DS24 General Plan and Community Plan Conformance

REVIEW OF THE PROPOSED PROJECT MAP – GENERAL PLAN

Figure 1: DS24 Existing, Proposed, and Alternative Land Use Maps

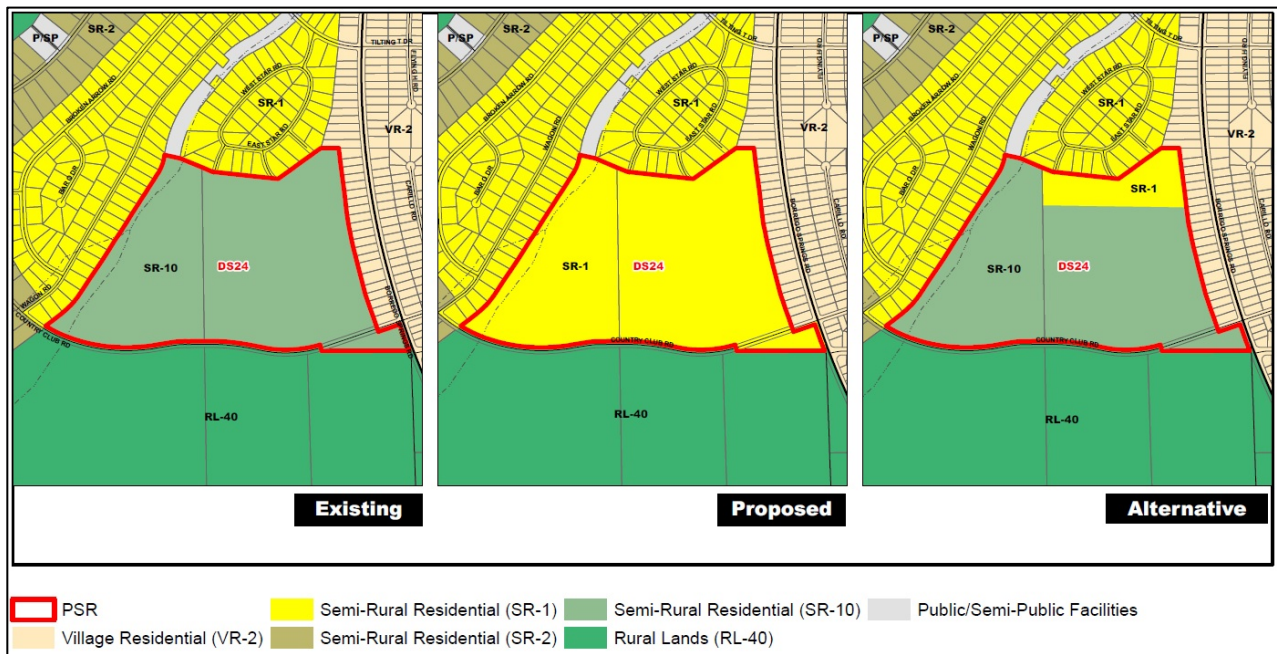
Due to the reasons summarized above, the proposal to apply a density 10 times that of the existing allowed density for the site would not be in line with the parameters of the CDM, as outlined in Guiding Principle 2. **Therefore, the Proposed Project Map has been found to be inconsistent with Policy LU-1.1.**

*As discussed in the review of Policy LU-1.1, the land use mapping pattern in the area of the DS24 site generally reflected parcel sizes existing at the time of the General Plan Update. Nearby areas of higher densities include pre-existing parcel sizes that generally reflect the applied density. The majority of these nearby areas of higher density are vacant, but are adjacent to public roads and water lines. The DS24 site shares many similarities with the adjacent Rural Lands to the south and west, including large parcel sizes, sensitive habitats, high flood hazard, and close proximity to State Park lands; however, it serves as a low density Semi-Rural edge and transition area between the parcelized area of higher densities and this Rural Lands area. **The proposed change to SR-1 would not be in line with the existing land use mapping pattern in this area; therefore, the Proposed Project Map has been found to be inconsistent with Policy LU-1.3.***

These issues are anticipated to substantially limit the feasibility of reaching the density potential of 169 units. **Therefore, the Proposed Project Map has been found to be inconsistent with Policy LU-1.9.**

Considering these issues, the Proposed Project Map has been found to be inconsistent with Policy LU-2.4.

*In terms of natural resources, the greatest obstacle for increased development in this CPA is the reliance on groundwater. Per the requirements of SGMA, a GSP will soon be prepared for the Borrego Valley, in order to ensure long term groundwater sustainability. Preliminary estimates indicate that the CPA may have to reduce groundwater use by 70% or more as part of implementing a GSP. Estimates from the Groundwater Study of the General Plan Update showed over 10,000 additional dwelling units would be possible when adding legally buildable vacant lots to the additional subdivision and multi-family development potential in the current Land Use Map for the CPA. As such, increasing allowed density within the CPA would further exacerbate an already critical overdraft situation. **Considering these issues, the Proposed Project Map has been found to be inconsistent with Policy LU-6.2.***

*The Proposed Project Map for DS24 was found to be inconsistent with General Plan Policies LU-1.1, LU-1.3, LU-1.9, LU-2.3, LU-2.4, LU-6.2, and COS-14.1, and Community Plan Policies LU-1.1.1, LU-2.1.1 and LU-1.5.1 as discussed earlier in this report. **The Alternative Map for DS24 has also been determined to be inconsistent with each of these policies, except General Plan Policies LU-1.9 and COS-14.1, for the same reasons as noted for the Proposed Project Map option.** The issues of excessive amounts of unbuilt available density in the community (existing buildable vacant lots, additional subdivision potential, and additional multi-family development potential on the current Land Use Map), and forthcoming reductions in groundwater use present difficult hurdles to overcome with regard to making community character consistency findings for increasing densities. Beyond groundwater resources, the highly sensitive habitats within DS24 are discussed in the review of LU-6.2 for the Proposed Project Map, and this issue remains with the Reduced Density Alternative Map, as the sensitive habitats are also within the SR-1 area of the Reduced Density Alternative Map. At this programmatic stand-alone GPA/Rezone stage, a consistency finding can be made for General Policy LU-1.9, as most of the portion that would change to SR-1 in that option would be out of the alluvial floodplain and most of the site would remain SR-10, which greatly reduces the unit potential and leaves more room for potential open space preservation requirements. In addition, a consistency finding can be made for General Plan Policy COS-14.1, as the much smaller area of SR-1 would be adjacent to existing homes, two public roads, and on the side closest to the Village and fire station. The Proposed Project Map was not found to be inconsistent with any other policies of the General Plan that are applicable to a stand-alone GPA/Rezone, nor was it found to be inconsistent with any other policies of the Community Plan when considered at this programmatic stand-alone GPA/Rezone approach. The same would hold true for the much lower density Alternative Map.*
